Review and Recommendation Memo and Report Data Assessment for HEC-RAS Unsteady Flow Modeling of the Upper Peace River

Southwest Florida Water Management District

December 2020

Figure 5 - Upper Peace River Water Surface Profiles by Chen's 2011 HEC-RAS Model Run, Version 5.0.7

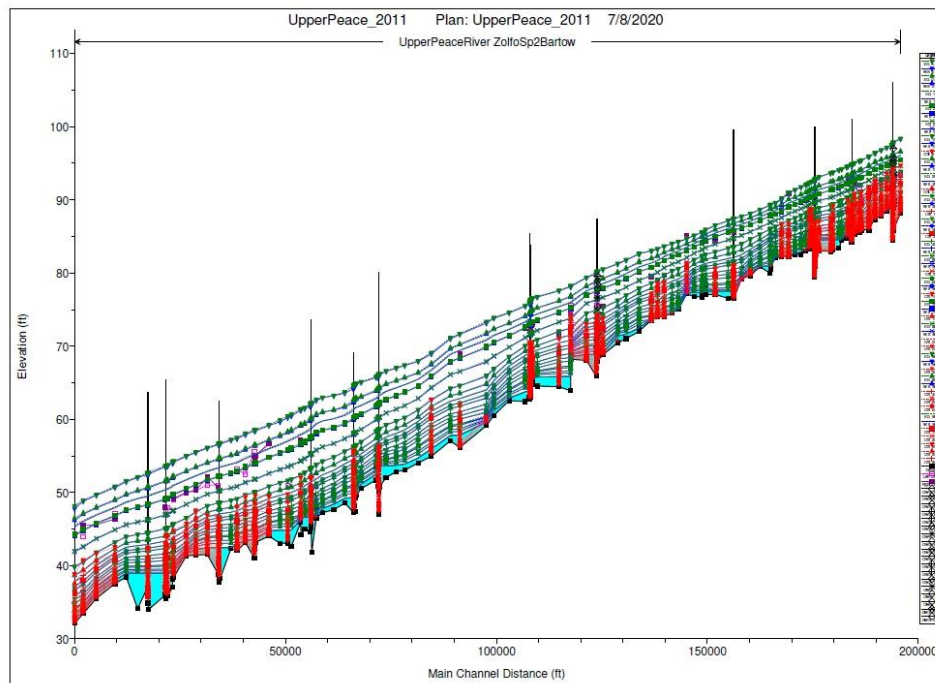
The HEC-RAS Version 4.0 was used in Chen’s 2011 model, but the software has continuously gone through multiple upgrades with the current Version 5.0.7 (March 2019). BFA obtained HEC-RAS for both Versions 4.0 and 5.0.7 and found that Chen’s 2011 model executed smoothly with both versions of HEC-RAS. Figure 5 presents the 18 water surface profiles computed with HEC-RAS Version 5.0.7. In the report (Chen 2011), Chen presented Figure 6 comparing the modeled and the targeted stages at the Fort Meade and Bartow stations, which showed a close match of the stages. To verify whether HEC-RAS versions 4.0 and 5.0.7 produced identical results for Chen’s 2011 model, the 50-percentile water surface profile was randomly chosen and ‘Detailed Output Tables’ from the two HEC-RAS versions were reviewed. The review revealed exactly matching results from the two versions as seen in Tables 3 and 4 for the River Station (RS) 588. The computed elevations for additional selected River Stations are as follows.

Figure 27: Example of HEC-RAS Cross-Section with a Vertical Wall on the Floodplain (River Station 504)

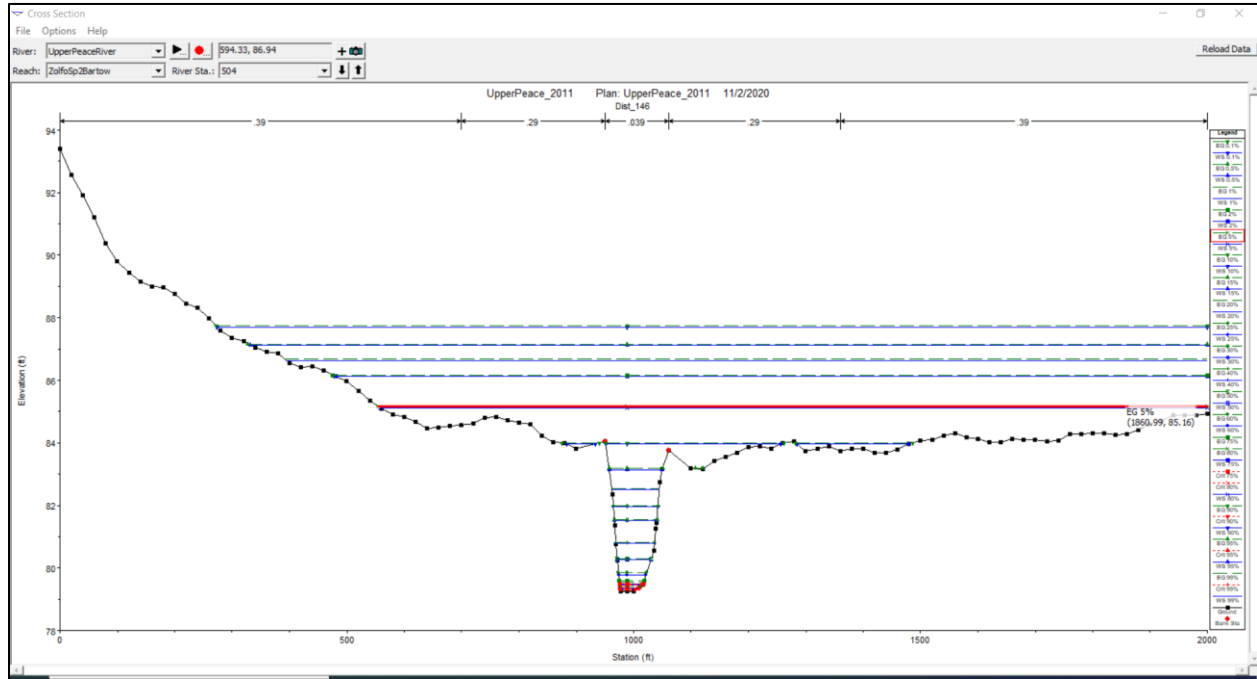
In HEC-RAS if a cross section does not extend sufficiently into the flood plain for a given flow, the program adds a fictitious “vertical wall” to the height of the computed water surface at the end of the cross section. Table 8 presents a list of the cross-sections that show a vertical wall on one or both sides for the 2011 HEC-RAS model. Hence, there are 126 cross-sections in the model that do not sufficiently extend into the floodplain to accommodate medium and high flows. Figure 27 depicts one of these HEC-RAS cross-sections with a vertical wall on the floodplain (River Station 504).

The use of a vertical wall introduces errors in the computed water surface elevation. In particular, errors in cross sectional area derived from the use this method, may lead to overestimated surface water levels. Also, some cross-sections may be missing a significant amount of wetted/flow area, and inundated areas may not show up correctly in mapping tools like RAS Mapper and HEC-GeoRAS. The magnitude of these errors will depend on the size of the missing wetted/flow area, the location of the missing wetted area (main channel, overbank or flow separation area), and the type of analysis used for modelling (steady/unsteady). For example, in HEC -RAS the missing flow area may be/is considered as ineffective area, which is accounted as hydraulic storage in the unsteady flow model. This approach may produce significant errors. Therefore, future modelling efforts should consider extending cross-sections further into the floodplain to improve the model’s accuracy for MFLs analyses.

A more detailed analysis should be performed in the next phase of the study to identify which cross-sections need to be revised/replaced and/or modified, and if additional cross-sections are needed. Newer surveys and LIDAR data listed above can be used to improve cross-sections geometry data.
